Commission for
Communications Regulation

Wideband Digital Mobile Data Services (WDMDS)

Response to request for licence amendment

Reference: ComReg 14/16

Fig.2 Transmitter Spectrum Mask

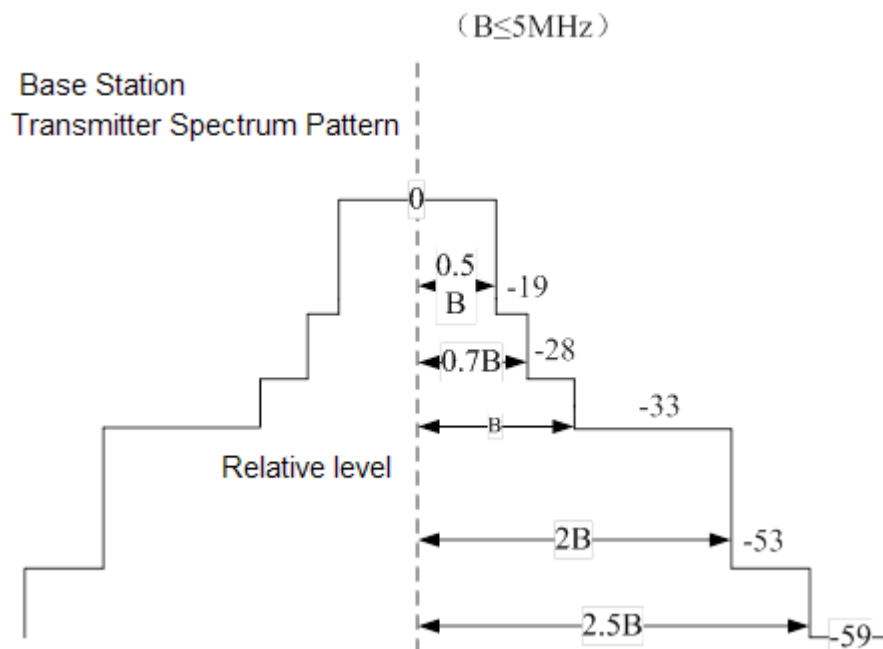
4. Table on page 4 item no.1 specifies an Antenna output power of 33 dBm but the note refers to output port. It is not clear to me if this is 33 dBm EIRP or not as the text on page 3 states “max output power of BTS shall not exceed 33 dBm/ 5 MHz.
